**DOMINION NUCLEAR CONNECTICUT, INC.**  
**MILLSTONE POWER STATION UNIT 3**  
**RESPONSE TO REQUEST FOR ADDITIONAL INFORMATION REGARDING**  
**A SPENT FUEL POOL STORAGE LICENSE AMENDMENT REQUEST**

**NON-PROPRIETARY RESPONSE TO RAI QUESTIONS 1 – 17**  
**FOR THE SPENT FUEL POOL LICENSE AMENDMENT REQUEST**

**NEU-08-50, Rev 1, Attachment 2 (Non-Proprietary)**  
**Westinghouse Response to Request for**  
**Additional Information (RAI) Regarding the**  
**Spent Fuel Pool Criticality Amendment Request**

Figure 1 Cell Blocker from Region I "3-out-of-4" Storage Configuration

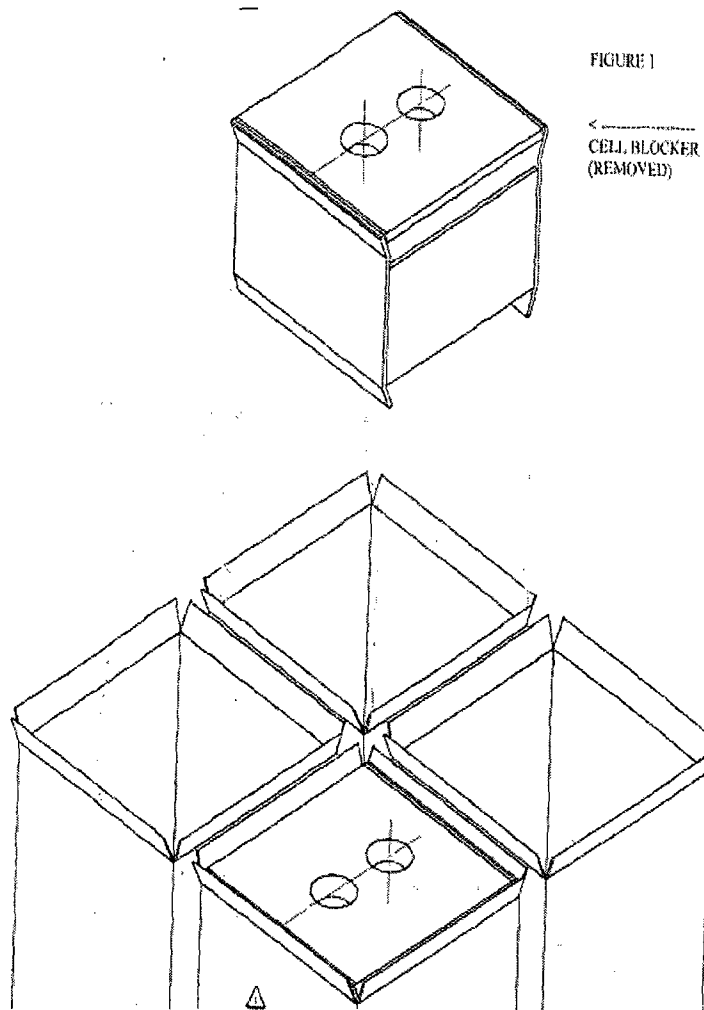
**WCAP-16721 Section 4.5.2, Soluble Boron Required to Mitigate Postulated Accident Effects, does not consider the misloading of a 5.0 weight percent <sup>235</sup>U fresh fuel assembly into location required to be empty in the Region I 3-out-of-4 storage configuration. Provide a justification for not including this accident scenario; include a description of the blocking device used and the controls which govern it.**

Figure 1 attached shows a schematic representation of a cell blocker in this "3-out-of-4" storage configuration. In Figure 1, a cell blocker is sketched in both the inserted and removed position, with 4 storage cells shown. The cell blocker is made of stainless steel and provides a clear visual indication to the fuel handler that fuel should not be placed in this blocked location. The cell blocker weighs about 30 pounds and has no mechanical attachment to the racks. The use of a
